**DURHAM DEVELOPMENT REVIEW**  
**D1500101 Duke University Central Generation Plant #3**  
**LEVEL 3 SITE PLAN**  
**1<sup>st</sup> Review**

SUBJECT: Duke University Central Generation Plant #3 - Review #1  
Case # D1500101 Case History:  
PIN: 0811-05-69-9253  
Address: 2100 Duke University Road (Wannamaker Drive)

LEVEL 3 SITE PLAN  
CASE NUMBER: D1500101  
JULY 14, 2015  
SECOND SUBMISSION

C-202

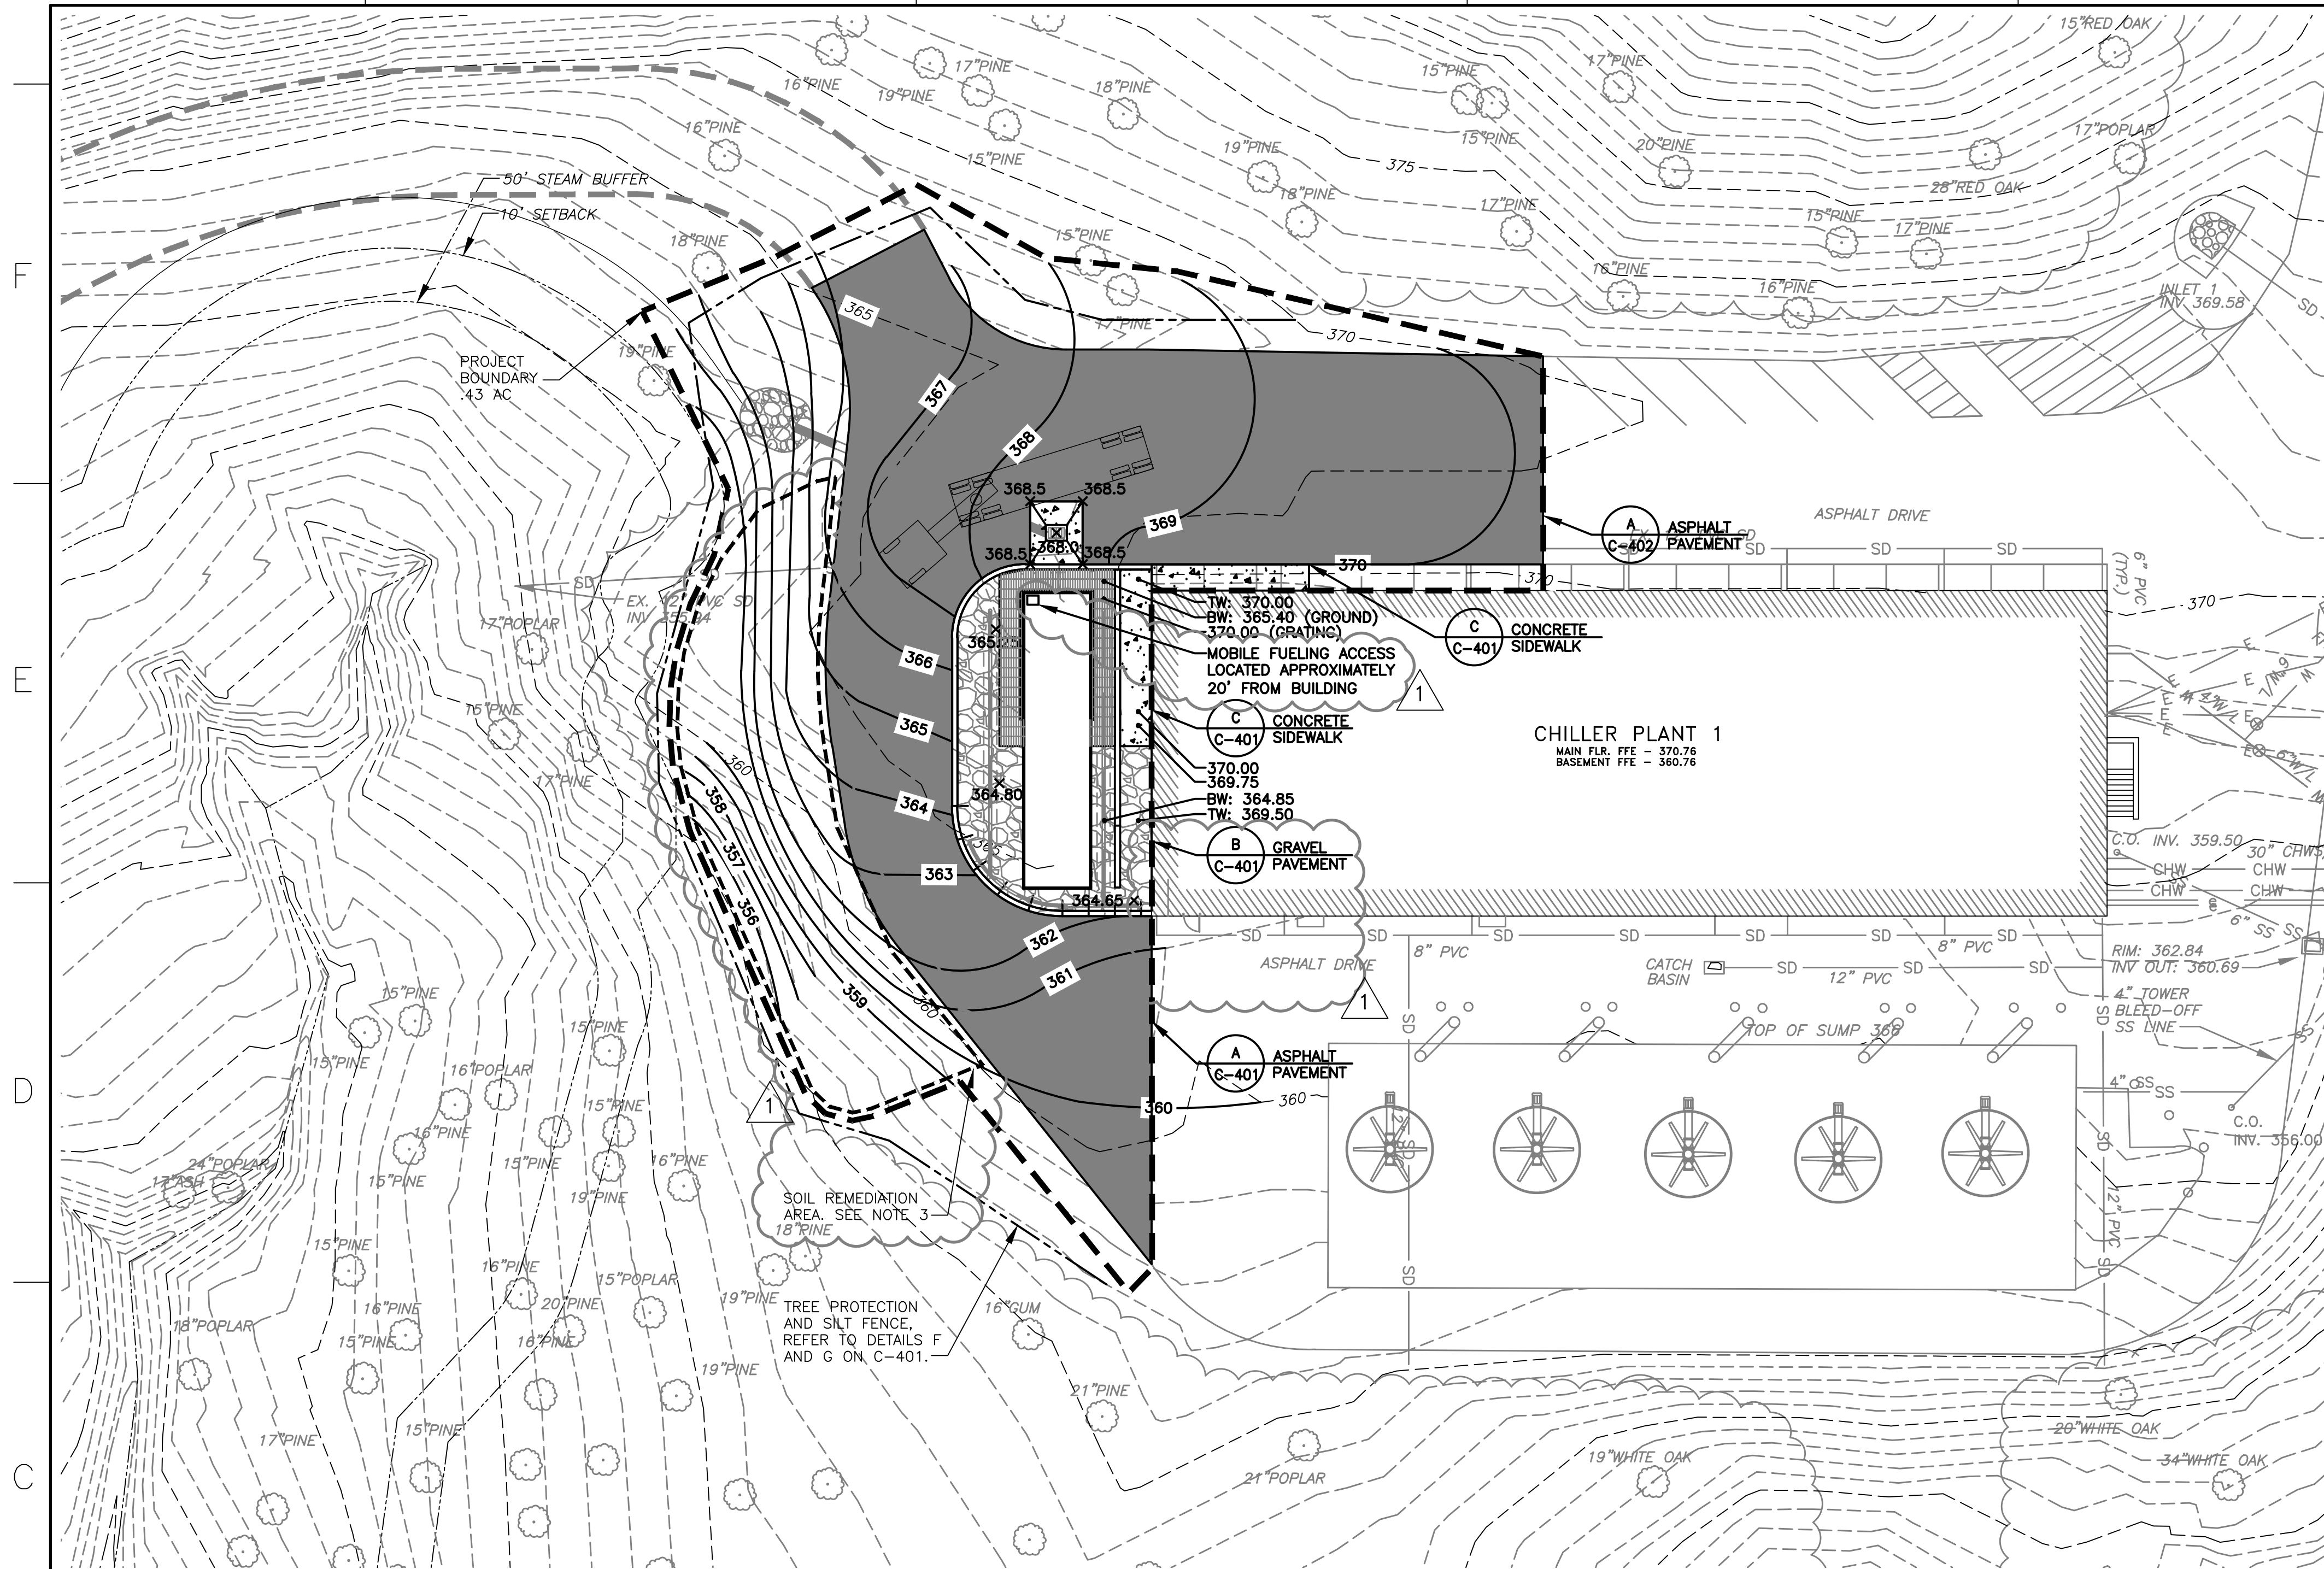
9. Graveled or paved areas that have supported vehicles or other weight are typically compacted down into the subgrade and are considered impervious. If this area is being included in the post-development "non-impervious" surface area, merely removing the gravel and putting sod on top will not render this area pervious. Please mark the boundaries of the area to be converted from

impervious to pervious surface and include the following note:

"The proper procedure for compacted soil remediation is as follows.

- a. Remove all impervious surfaces from the subject area.
- b. Till the area to a depth of 12" below the top of compacted subgrade.
- c. Suitable rates and types of soil amendments should be determined through soil tests. Limestone and fertilizer should be applied uniformly during seedbed preparation and mixed well with the top 4 to 6 inches of soil."

Site plan needs to include all required elements of Section 3406.5.1 of the NC Fire Code pertaining to the bulk transfer of liquids between the tank vehicle and storage tank.

**RESPONSE: The above notes have been added to the site plan (C-202) and called out in plan where applicable. The area has been outlined with a dashed line in plan and called out and added to the legend.**

**RESPONSE: The following changes have been made to address 3406.5.1:**

- **Called out location of mobile fueling to clarify that it is further than 15' from any buildings on C-202**
- **No weather canopy will be provided. No mechanical ventilation will be required; natural ventilation is effective for the application.**
- **Called out "No Smoking Within 25 Feet of Tank" signage on C-202.**
- **Detailed what provisions have been provided for spill control on C-201. Spill containment area is called out in plan, and Note 2 has been added detailing requirements.**
- **A 5' tall fence around the fueling area has not been provided. Per 3406.5.1.18 Exception: no fence is necessary due to the site's isolation and natural barriers from the public.**
